**Request for Bid
#12-0114
Adult Detention Facility Master Control Upgrade
Addendum #5**

March 29, 2013

Project Title:
SEDGWICK COUNTY
ADULT DETENTION FACILITY
MASTER CONTROL UPGRADE
WICHITA, KANSAS

Supplemental Drawing Number: SD-DE02	
Reference Sheet Number: DE8.0	
Project Number: 111369	Revised By: A&O
Date Issued: 03-29-13	Issued With: Addendum #5

15 DOOR PULL RETRO-FIT (TYPICAL)
 DE8.0 SCALE: NONE

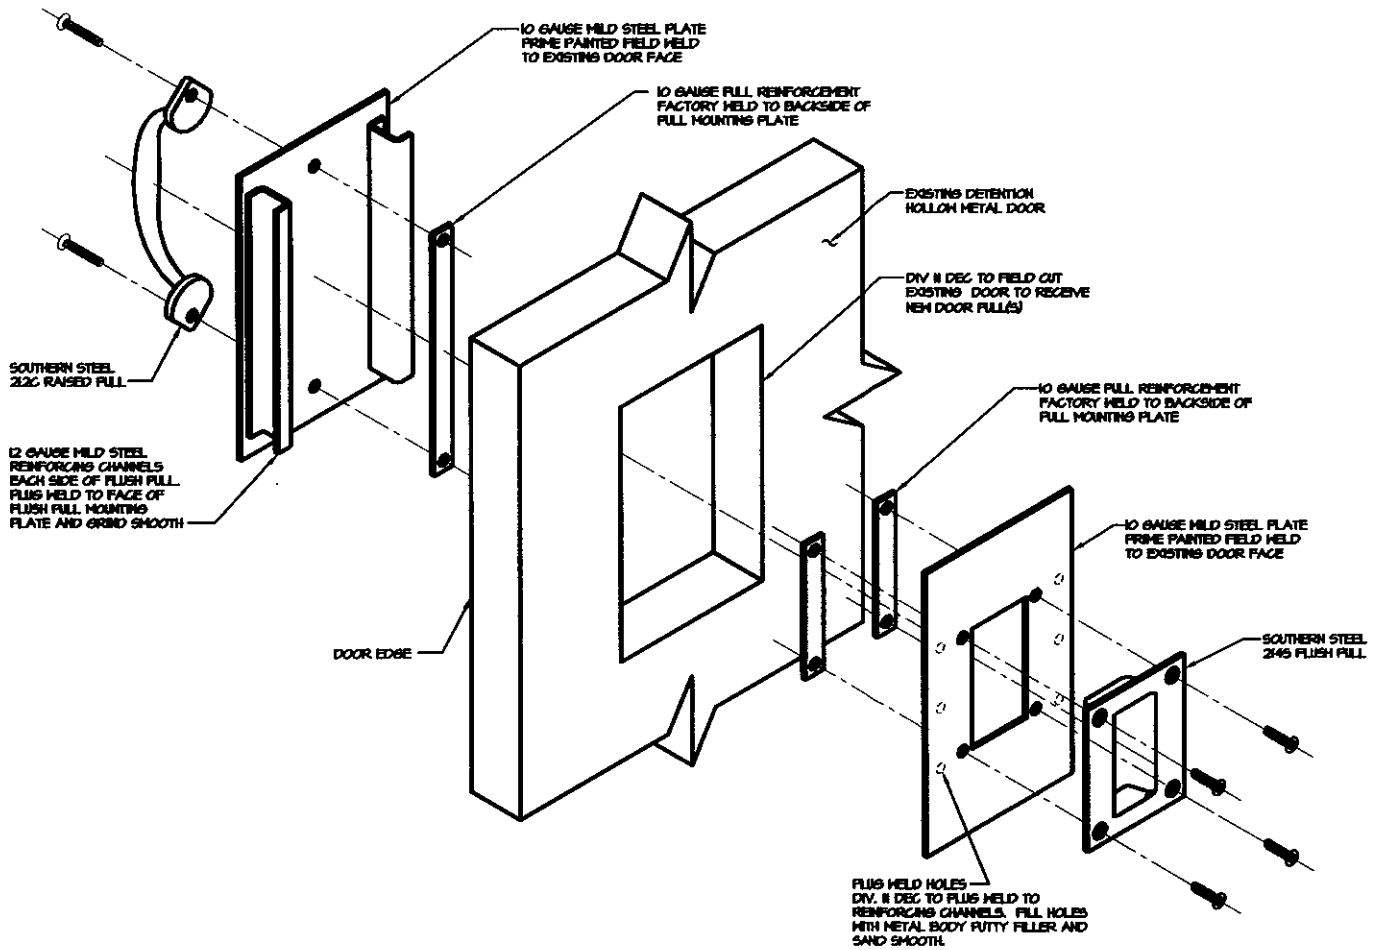
21. Sheet DE8.0 – Detention Equipment Details

- a. Add Detail 15/DE8.0 per Supplemental Drawing SD-DE02 attached to this Addendum.
